SERVICE BULLETIN

SB No. 52 Issue No. 2

TITLE
ELEVATOR HORN WATER INGRESS

VIEW ON UNDERSIDE OF
PORT ELEVATOR HORN
FIG. 1

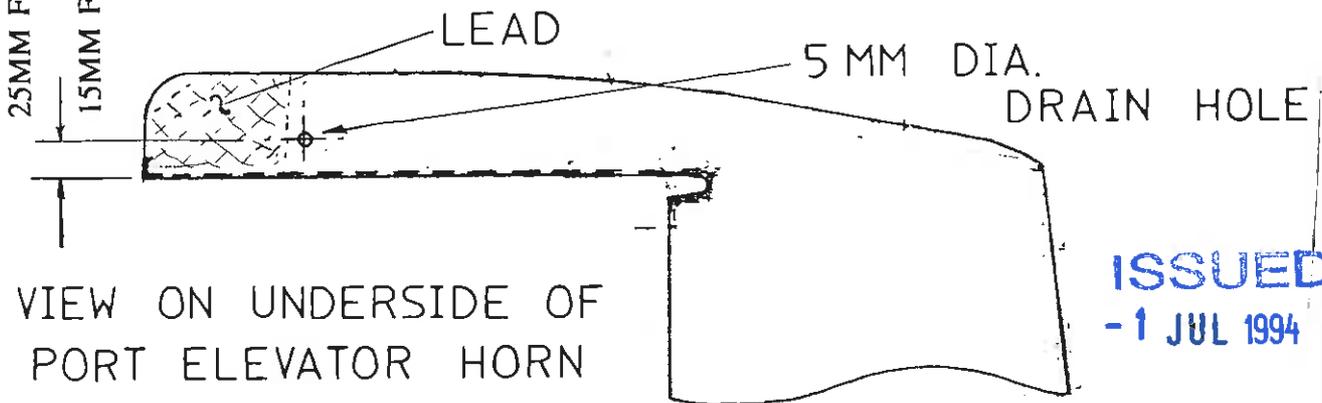
1. Deflect elevators to up position.
2. By tapping the inside face of the horn balance with a coin, the position of the lead balance weight can be ascertained.
3. Ref. Fig 1 drill 5mm dia hole in the lower skin of the horn in the hollow portion as close to the lead balance as possible.
4. Check the condition of the vinyl disc T67B-00-301 which covers the elevator hinge pivot. Renew as necessary.

25MM FOR T67B AIRCRAFT
15MM FOR ALL OTHER TYPES
